April 6, 2016

RE: River Bank Stabilization Project along the Middle Fork Vermilion River; Vermilion Site;
10/5/2015 Joint Application #LRL-2008-1366 at Dynegy's coal ash storage facility

These comments are submitted on behalf of Prairie Rivers Network regarding the proposed River Bank Stabilization Project for the Vermilion Power Station, submitted by Dynegy Midwest Generation for joint review and approval by the National Park Service (NPS), US Army Corps of Engineers (USACE), Illinois Department of Natural Resources (IDNR), and Illinois Environmental Protection Agency (IEPA).

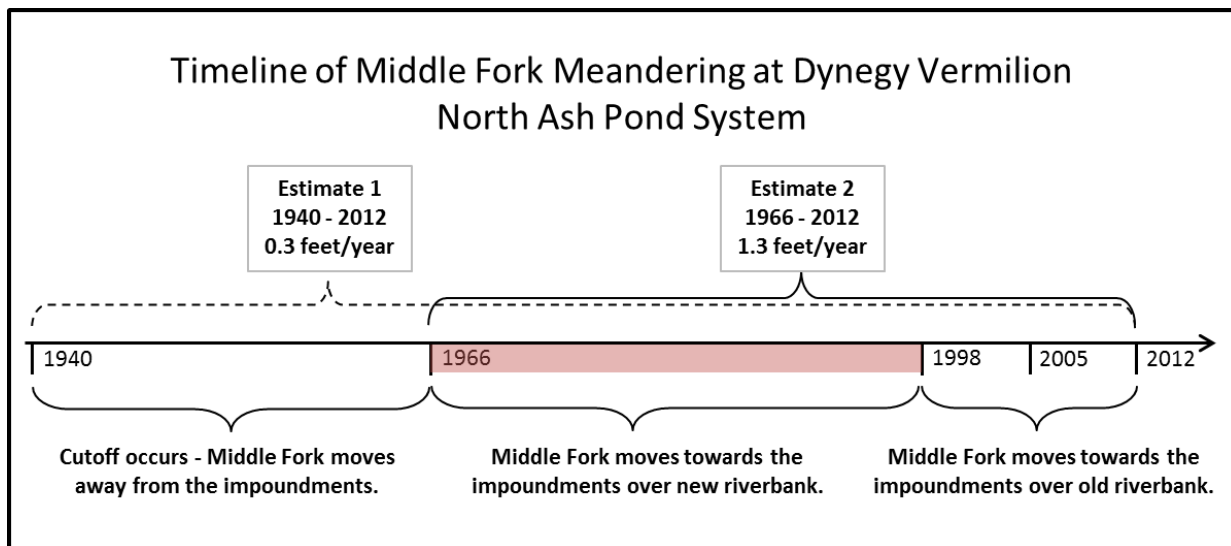
The gabions in question (some pictured below) remain in disrepair – shredded, slumping into the river, and in many places completely absent.

Given Dynegy's record of neglect of the old gabions, what action can agencies take to assure the public that Dynegy will monitor and maintain any new bank armoring installed at a retired plant?
